# HARDWARE PATCH for Zemmix Neo, SX-1, SM-X and related machines ( update 2020.04.06 )

## 2020.08.19 Hardware Patch for OCM machines “aka BUSDIR\_n patch”

## 2020.10.16 Hardware patch for Zemmix Neo BR machines (aka +5V line stability fix)

# 2022.06.02 Hardware Patch for SM-X, SX-2 and related machines

### THE FIX:

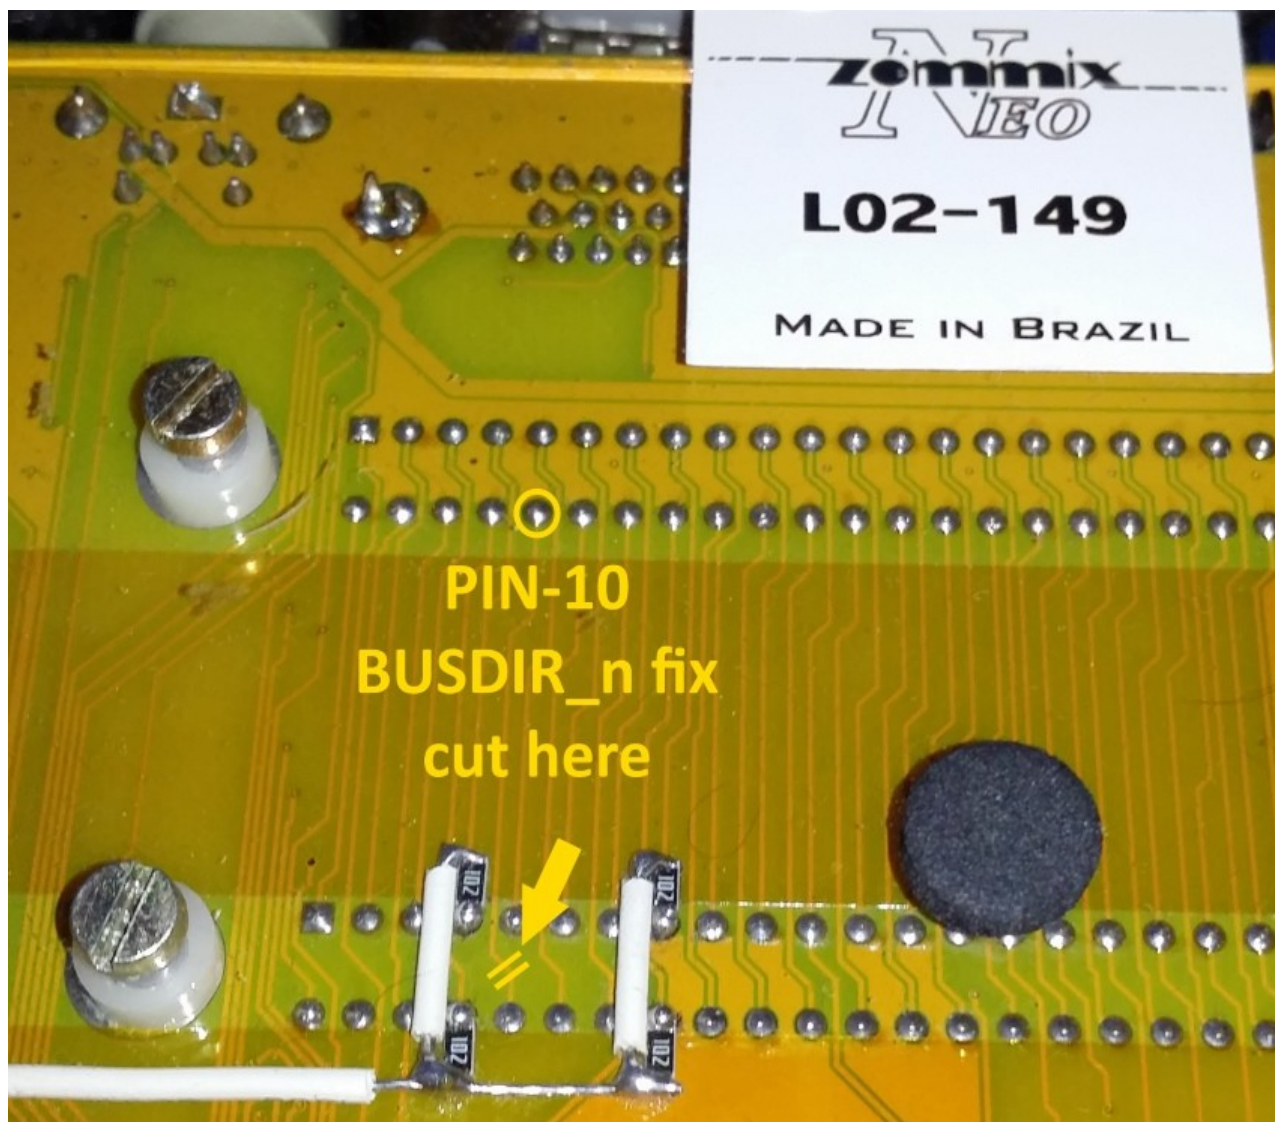
- In OCM machines we have a short circuit between pin-10 (BUSDIR\_n) of the two external slots that continues towards the FPGA. This type of connection confuses some cartridges.
- While the Panasonic FS-A1ST and Canon V-20 service manuals confirmed that the BUSDIR signal is not used.

- Pin-10 (BUSDIR\_n) of the external slots must be isolated.

- Method 1 - Cut the track that connects pin-10 of Slot-1 and Slot-2 leaving unchanged the connection to the FPGA already internally isolated by the firmware.
- Method 2 - Desolder pin-10 of slot-2 from the PCB and insulate it with the sheath of an electric wire and a drop of hot glue.
- Method 3 - Place non conducting tape over pin 10 of those cartridges that are not working properly, such as MoonSound and Darky.

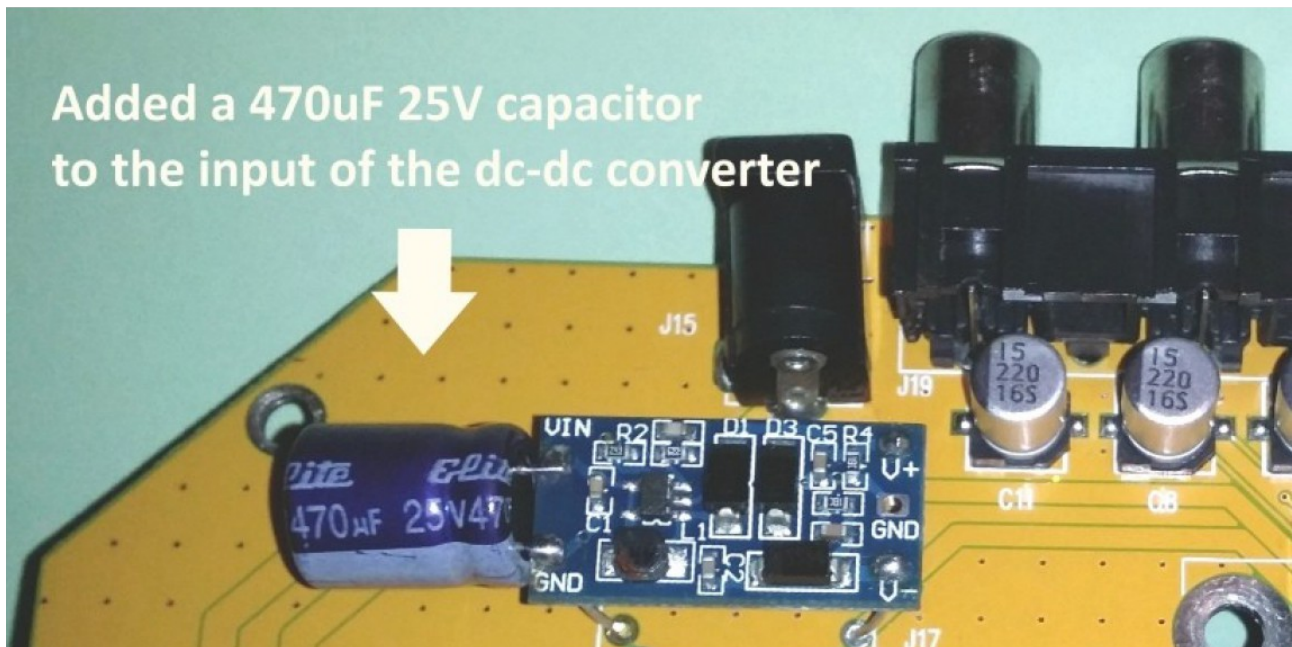
Based on the wiring diagram of the original 1chipMSX machine, I have implemented this new hardware patch for Zemmix Neo Brazilian which allows to stabilize the +5V input line. This patch can for example remove some annoying video interference on the output of GFX9000 and other similar cartridges. Please be informed that the problem is currently only present on Zemmix Neo Brazilian and not with Zemmix Neo Korean, but this fix can still be used if your hardware is unstable.

(aka PS/2 keyboard compatibility fix) [ Revision 2 ]

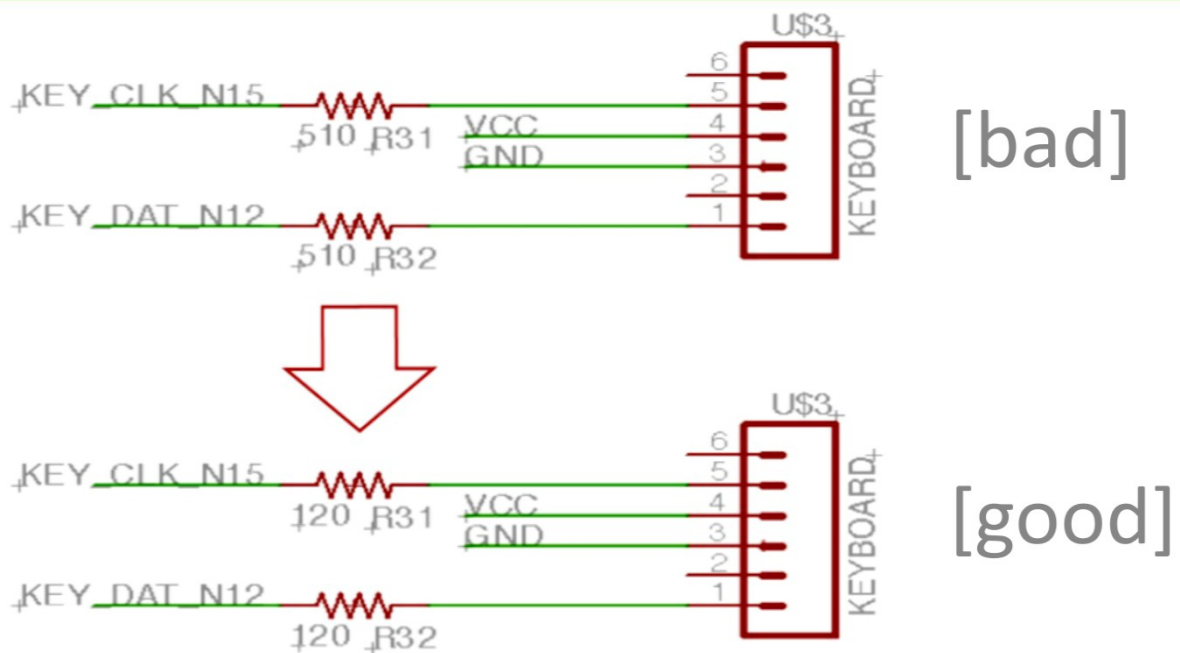
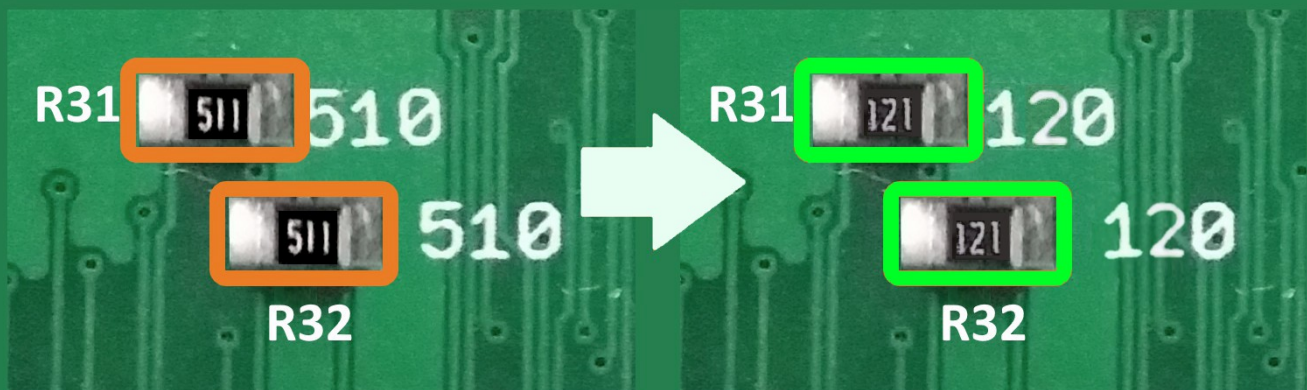
**This is an optional fix. If your keyboard is NOT working properly  
you can apply this hardware patch or purchase another keyboard.**

**How to do it: replace the resistors  
R31 and R32 with a value between 120  $\Omega$  and 390  $\Omega$ .  
A value of 120  $\Omega$  is recommended to ensure maximum compatibility.**

## - External Data Bus 10MHz fix

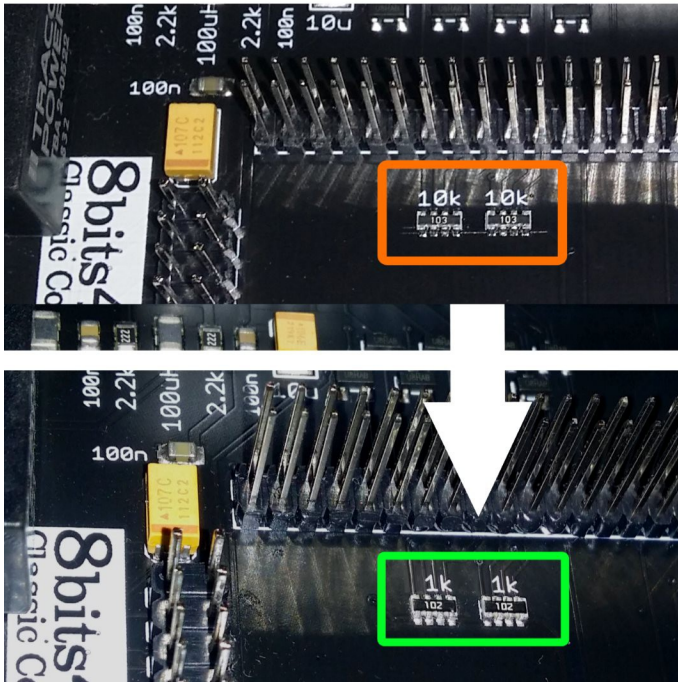
- The first hardware patch (photo left) solves a compatibility issue with the 10 MHz data bus and consists of replacing the 10K resistor arrays with equivalent 1K ones. To verify proper operation, run the following commands: `CPUSPEED /7` and then `SAVEROM TEST.ROM /S` without inserting the cartridges into the slots. If slots 1 and 2 appear listed on the screen, it means that the change was not performed correctly. Otherwise, everything is fine.

## - Strengthened Reset Button

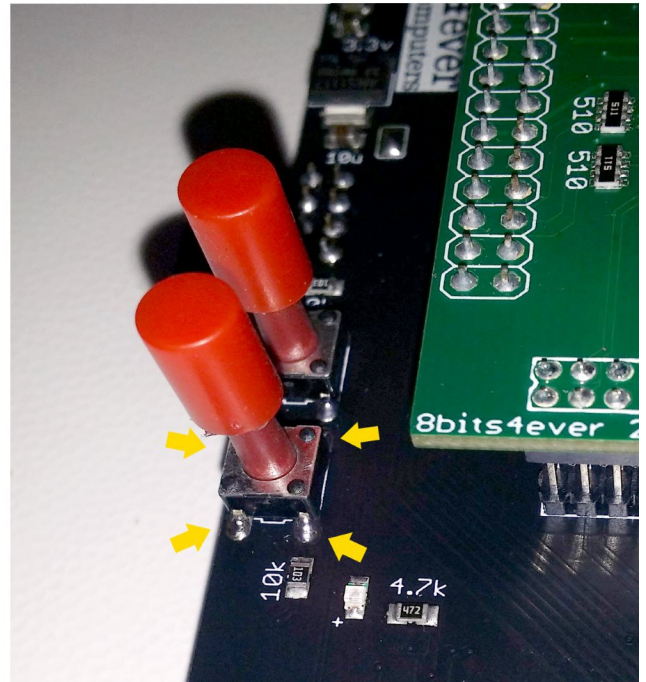
- The second hardware patch (photo right) solves a stability issue with the reset button. You only need to solder the button to the top of the pcb to fix any malfunctions. To perform a test, you need to press the reset button for a long time and move your finger in a circle. If the machine restarts, it means the soldering is incomplete. If the screen remains black, it means the soldering is fine.
